Project	IEEE 802.16 Broadband Wireless Access Working Group < http://ieee802.org/16 >	
Title	Symmetric UL/DL diversity permutations for OFDMA PHY	
Date Submitted	2005-1-11	
Source(s)	Ran Yaniv, Tal Kaitz, Vladimir Yanover, Naftali Chayat Alvarion Ltd. Yuval Lomnitz Intel Dave Pechner, Todd Chauvin, Doug C. Dahlby ArrayComm Bin-Chul Ihm, Yongseok Jin, Jinyoung Chun, Kyuhyuk Chung LG Electronics, Inc.	ran.yaniv@alvarion.com tal.kaitz@alvarion.com yuval.lomnitz@intel.com dpechner@arraycomm.com chauvin@arraycomm.com dahlby@arraycomm.com bcihm@lge.com jayjay@lge.com jychun03@lge.com kyuhyuk@lge.com
Re:	Call for contributions, IEEE P802.16e/D5 Sponsor Ballot	
Abstract		
Purpose		
Notice	This document has been prepared to assist IEEE 802.16. It is offered as a basis for discussion and is not binding on the contributing individual(s) or organization(s). The material in this document is subject to change in form and content after further study. The contributor(s) reserve(s) the right to add, amend or withdraw material contained herein.

Symmetric UL/DL diversity permutations for OFDMA PHY

Figure 219 – Illustration of OFDMA frame with multiple zones

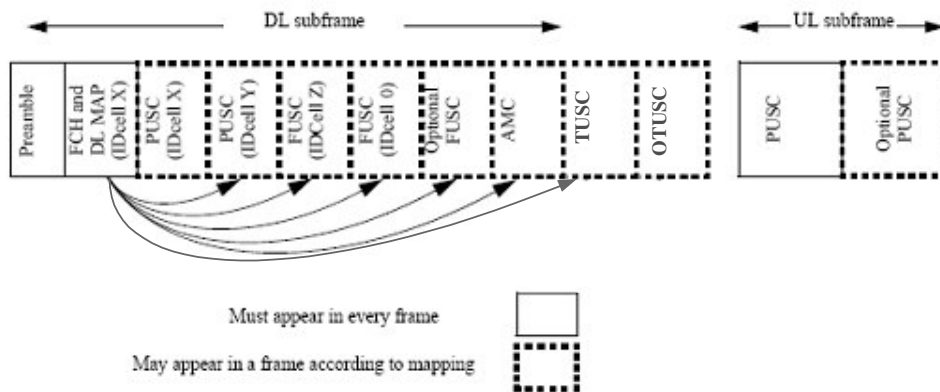
The OFDMA frame may include multiple zones (such as PUSC, FUSC, PUSC with all subchannels, optional FUSC, AMC, ~~and~~ optional FUSC with all subchannels, TUSC, and optional TUSC), the transition between zones is indicated in the DL-Map by the Zone_switch IE (see 8.4.5.3.4). No DL-MAP or UL-MAP allocations can span over multiple zones. Figure 219 depict OFDMA frame with multiple zones.

3. [Replace figure 219 on page 503 with the following figure]

Figure XXX – Mapping of data subcarriers in STC for TUSC with matrix indicator A.

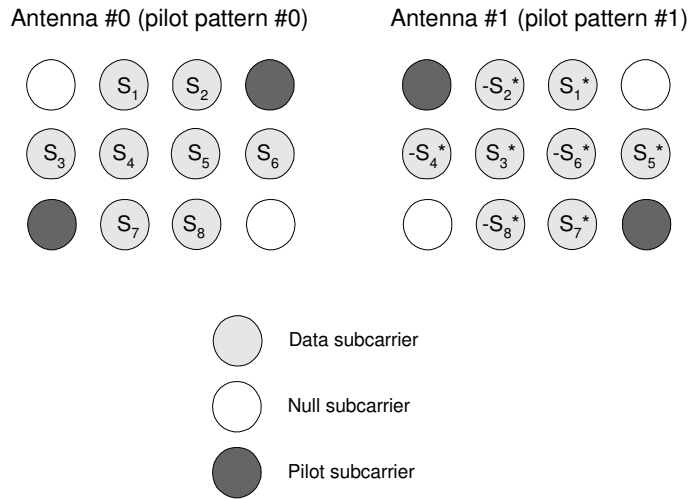
Two STC modes for 2-antenna configuration are defined for the TUSC permutation. In both modes, the pilots in each tile shall be split between the two antennas as depicted in figure XXX. In the first mode, identified by STC matrix indicator 'A', data subcarriers are encoded within each tile after constellation mapping. In this mode, the

[files shall be allocated to subchannels and the data subcarriers enumerated as defined in 8.4.6.1.2.4. The data subcarriers transmitted from Antenna #0 follow the original mapping defined in 8.4.6.1.2.4.](#)
